Access Compliance Report

Public Rights-of-Way

(Curb Ramps)

Intersection ID: 21955	Main Street: DELPOND_LN	Cross Street: SUTTON_SPRINGS_RD	Location: W
ADA ID: 083C42FC9921	Ramp Type: PerpDiag	Initial Pass/Fail: Fail	Overall Compliance: No
Severity Score: 33.75			
Codes/Mitigation Info/Possible Solution		Field Measurements/Component Compliance

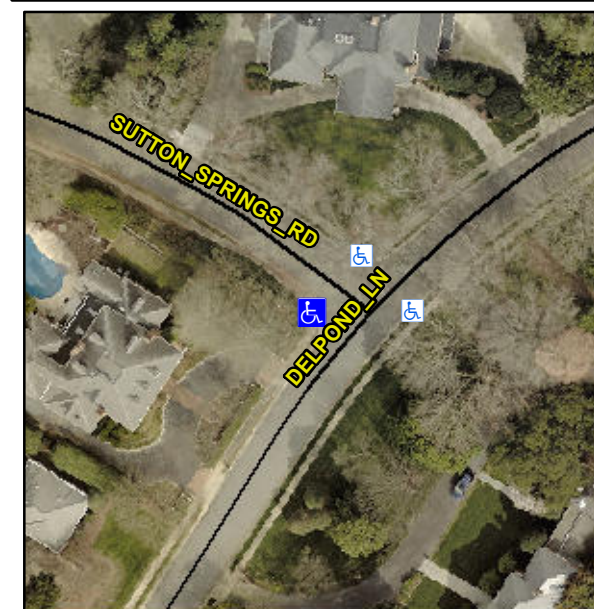
Not Found, R304.5.1, R304.5.3

Compliance	Description	Data	Compliance	Description	Data
N/A	Ramp Length (in)	47.0	Yes	Ramp Slope (%)	6.9
No	Ramp Width (in)	41.0	No	Ramp XSlope (%)	8.9
N/A	Flare Type LT	N/A	N/A	Flare Type RT	N/A
N/A	Flare Slope LT (%)	N/A	N/A	Flare Slope RT (%)	N/A
N/A	Flare Traversable LT?	N/A	N/A	Flare Traversable RT?	N/A
N/A	Landing Length (in)	N/A	N/A	DWS Provided?	N/A
N/A	Landing Width (in)	N/A	N/A	DWS Contrast?	N/A
N/A	Landing Slope (%)	N/A	N/A	DWS Length (in)	N/A
N/A	Landing X Slope (%)	N/A	N/A	DWS Full Width?	N/A
N/A	Landing Curb? (Y/N)	N/A	N/A	DWS Offset (in)	N/A
N/A	Shared Landing?	N/A			
N/A	Gutter Ponding?	N/A	N/A	Gutter Slope (%)	N/A
N/A	Gutter Lip Ht (in)	N/A	N/A	Gutter X Slope (%)	N/A
N/A	Painted X Walk1?	No	N/A	Painted X Walk2?	No
	X Walk 1 Direction	To SE		X Walk 2 Direction	To NE
N/A	X Walk 1 Width (in)	N/A	N/A	X Walk 2 Width (in)	N/A
	X Walk 1 Slope (%)	5.1		X Walk 2 Slope (%)	1.8
	X Walk 1 X Slope (%)	3.2		X Walk 2 X Slope (%)	6.4

Remove & Replace Curb Ramp With Two New Directional Ramps or Equivalent.
